E5071C-55

Information Only Service Note

E5071C ENA Series Network Analyzer, 9kHz to 20GHz

E5071C Touch Panel Controller & Solid State Drive compatibility reference

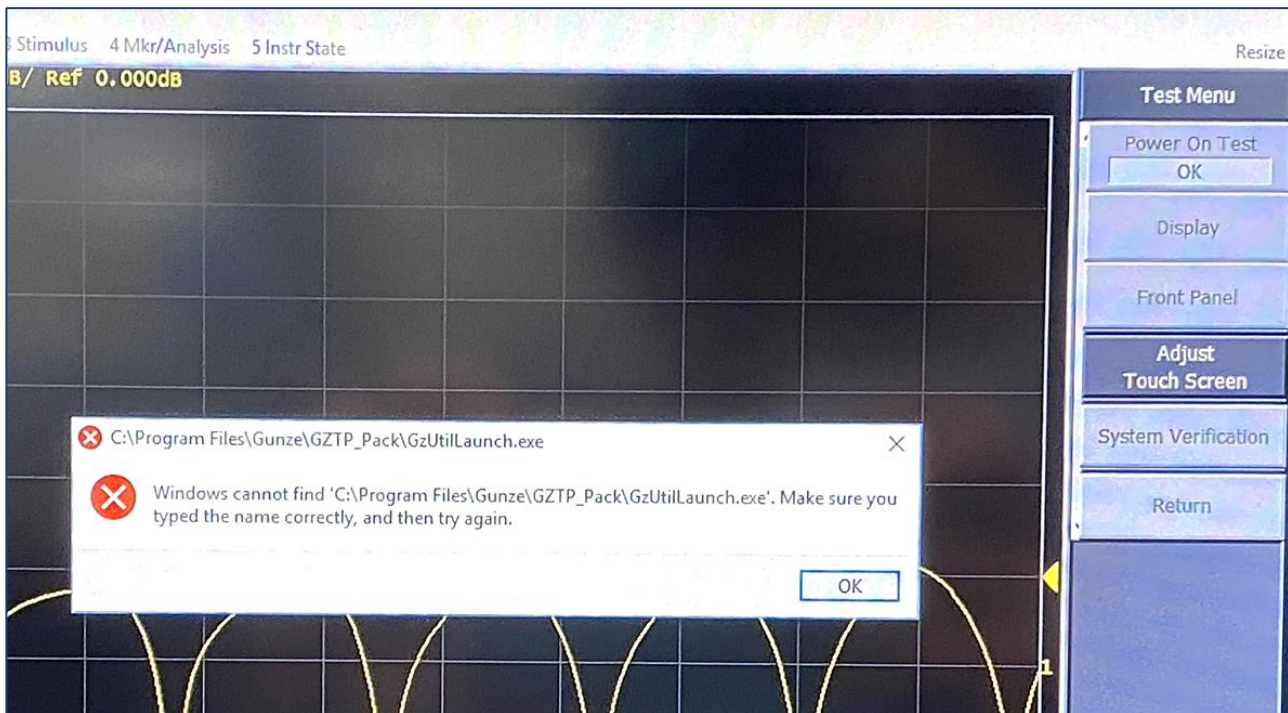
Incorrect combination of Touch panel and SSD will either result in unsupported touch panel controller or unexpected response to user touch inputs. The following error message will be prompted whenever user click on the “Adjust Touch Screen” function.

“Windows cannot find “C:\Program Files\Gunze\GZTP_Pack\GzUtilaunch.exe”. Make sure you typed the name correctly, and then try again.”

The solution to this is to either replace a brand new unused SSD or to repair as-is with the identical generation touch panel controller board.

Shown is the visual comparison of old vs new touch panel controller.

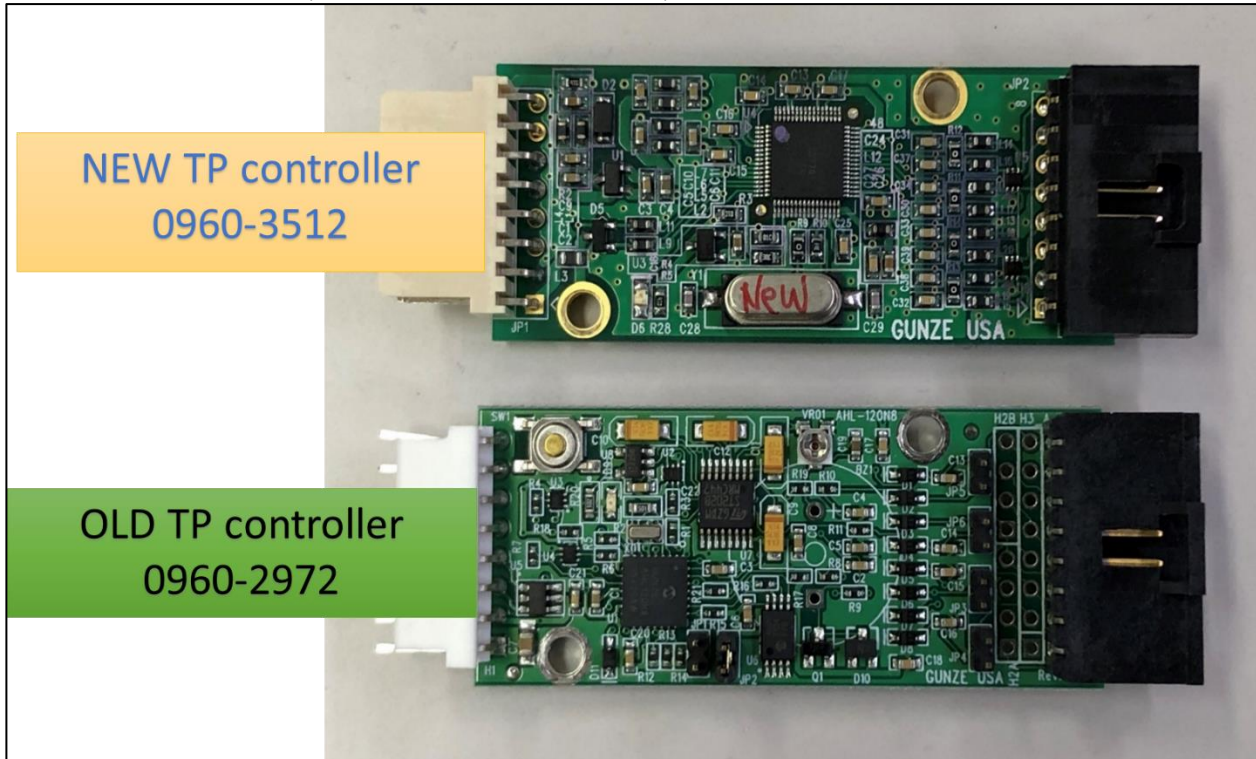
Earlier generation of touch panel controller board has been discontinued by supplier.

New touch panel controller is not a drop-in replacement and can only be supported by the identified SSD storage image (FW revision) or newer.

1. For Official Win-10 with MY470/ SG470 serial number prefix and above, replace with **new** touch panel controller 0960-3512. This generation SSD supports the new touch panel since day-1.
2. For Official Win-10 with MY467/8/9, SG467/8/9 serial number prefix fitted with **new** touch panel controller, replace with **new** touch panel controller 0960-3512. This covers the Win-10 based E5071C which had its touch panel controller replaced along with the port or freq. upgrade conversion.
3. For Official Win-10 with MY467/8/9, SG467/8/9 fitted with **old** touch panel controller, replace with **old** touch panel controller 0960-2972.
4. For Win-10 E5071C upgraded from earlier Win-XP/ 7 generations (sn prefix of MY461-466,SG461-466) fitted with **old** touch panel controller, replace with **old** touch panel controller 0960-2972.

Combinations	Original Touch Panel Controller	Replace with	Action needed
1	0960-2972	0960-2972	NA. Replace as is.
2	0960-2972	0960-3512 + E5071-82307 *1	SSD image needs to be Storage revision CG1410 (FW Rev B.14.10) or newer
3	0960-3512	0960-3512	NA. Replace as is.

*1. CG1410++ (original FW B.14.10++) or newer SSD image supports both old and new touch panel controller.
